CR-Formv3
CHANGE REQUEST
⚡ 25.225 CR CR-Num ⚡ rev - ⚡ Current version: 3.4.0 ⚡

Title:	⚡ CR for TS25.225 regarding 1.28 Mcps TDD		
Source:	⚡ CWTS/CATT		
Work item code:	⚡ 1.28 Mcps TDD Physical Layer	Date:	⚡
Category:	⚡ B	Release:	⚡ REL-4
	Use <u>one</u> of the following categories: F (essential correction) A (corresponds to a correction in an earlier release) B (Addition of feature), C (Functional modification of feature) D (Editorial modification) Detailed explanations of the above categories can be found in 3GPP TR 21.900.		Use <u>one</u> of the following releases: 2 (GSM Phase 2) R96 (Release 1996) R97 (Release 1997) R98 (Release 1998) R99 (Release 1999) REL-4 (Release 4) REL-5 (Release 5)

Reason for change:	⚡ This CR collects the principally agreed wording of the changes necessary for introducing the feature 'Low Chip Rate TDD option' in the TS25.225. In its last revision it should be editorially changed to reflect the correct changes needed for the latest approved version of this specification.
Summary of change:	⚡
Consequences if not approved:	⚡

Figure A.1: Possible idle periods in a subframe with two occupied timeslots

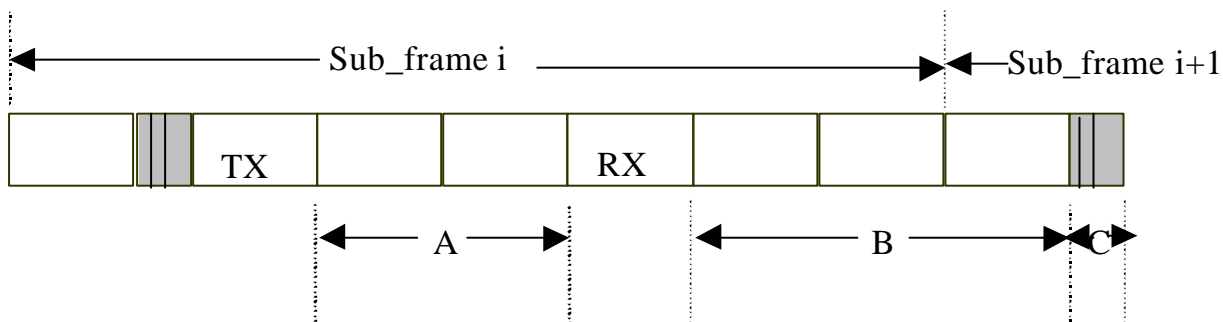
A.2 Low data rate traffic using 1 uplink and 1 downlink slot (for the 1.28 Mcps option)

If a single synthesiser UE uses only one uplink and one downlink slot, e.g. for speech communication, the UE is not in transmit or receive state during 5 slots in each frame. According to the timeslot numbers allocated to the traffic, this period can be split into two continuous idle intervals A and B as shown in the figure below.

A is defined as the number of idle slots between the Tx and Rx slots and B the number of idle slots between the Rx and Tx slots. It is clear that $A+B=5$ time slots and C is equal to the $DwPTS+GP+UpPTS$.

In the scope of low cost terminals, a [0.5] ms period is supposed to be required to perform a frequency jump from 1.28Mcps TDD to GSM and vice versa. This lets possibly two free periods of $A*Timeslots-1$ ms and $B*Timeslots+C-1$ ms during which the mobile station can monitor GSM. Timeslots being the slot period.
